## SUMMARY OF CONCERNS IN RELATION TO THE PROPOSED NORTHCONNEX TUNNEL

**This is an objection to many aspects of the proposed NorthConnex tunnel.**

MOTORWAY OPERATIONS COMPLEX - SOUTHERN VENTILATION FACILITY - SECTIONS  
M1-M2-5000-DR-JD-0525

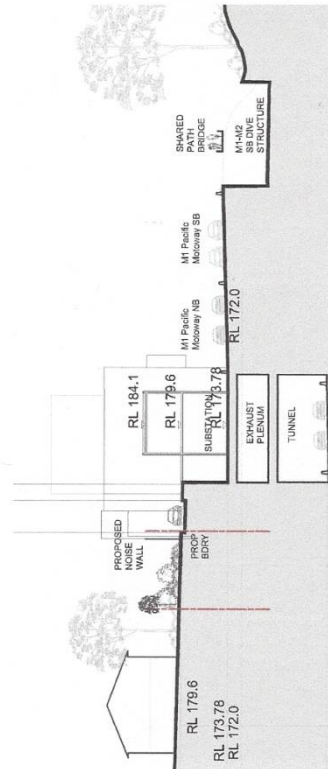
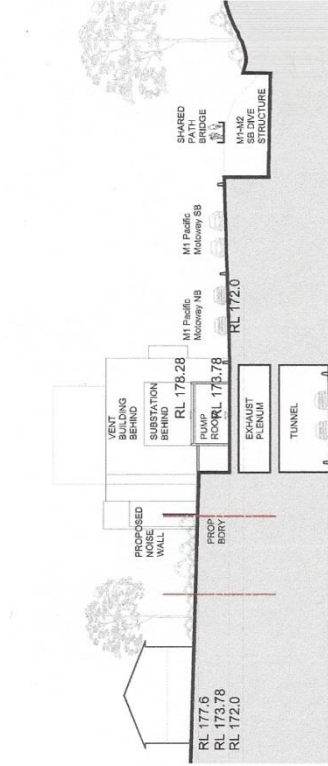
5. *EIS Volume 4, Technical working papers - Urban Design, 6.0 Operational Ancillary Facilities*  
EIS Page 99 there is the diagram "Motorway Operations Complex – Southern Ventilation Facility – sections. *Page 10 below* The diagram has the cryptic label "Connection to tunnel TBC". What does TBC stand for? To be considered? Why is tunnel singular? Which tunnel is the diagram referring to northbound or southbound? There is no diagram showing any connection from the Southern Interchange ventilation facility to either the northbound or the southbound tunnel in any way AND YET ....

6. *EIS Volume 4, Technical working papers Urban Design, 8.0 Landscape Design*  
EIS Page 176 is the diagram "Motorway Operations Complex – Southern Ventilation Facility – Site 1-1". *Page 13 below* The diagram does not show any connection to either the northbound or southbound tunnel. In the same Landscape Design section, EIS Page 182 is the diagram "Wilson Road Tunnel Support Facility –Section" *Page 14 below* which clearly shows the connection to the tunnels. In the same Landscape Design section, EIS Page 189 is the diagram "Northern Ventilation Facility – Landscape Concept Section". *Page 15 below* This also clearly shows the connection to the tunnels.

- Diagrams need to be provided showing the inter-relation between the shaft, the ventilation outlet and the motorway operations centre with a clear description of what is to be constructed and how it will operate.
- The community needs irrefutable evidence that the polluted air from the southbound tunnel exit portals will not be allowed to flow like an invisible sewer through West Pennant Hills, North Rocks, Carlingford and Beecroft.

M1-M2-5000-DR-UD-0725  
NORTHERN VENTILATION FACILITY - LANDSCAPE CONCEPT SECTION

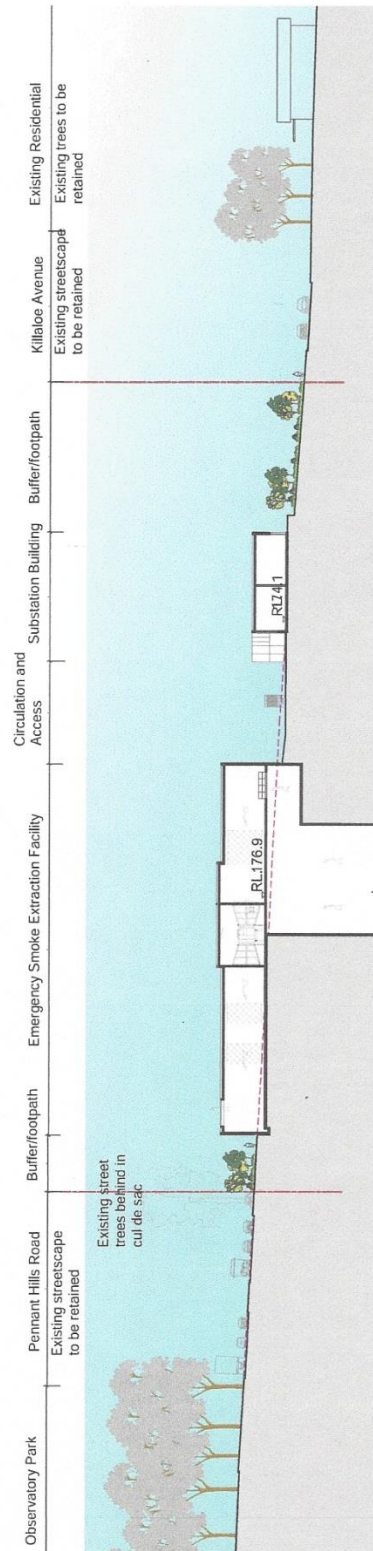
EIS page 135 *Page 11 below* there is a very explicit diagram showing the *Northern Ventilation Facility – cross section*.

EIS page 134 *Page 12 below* there is a very explicit diagram showing the *Northern Ventilation Facility – long section*.
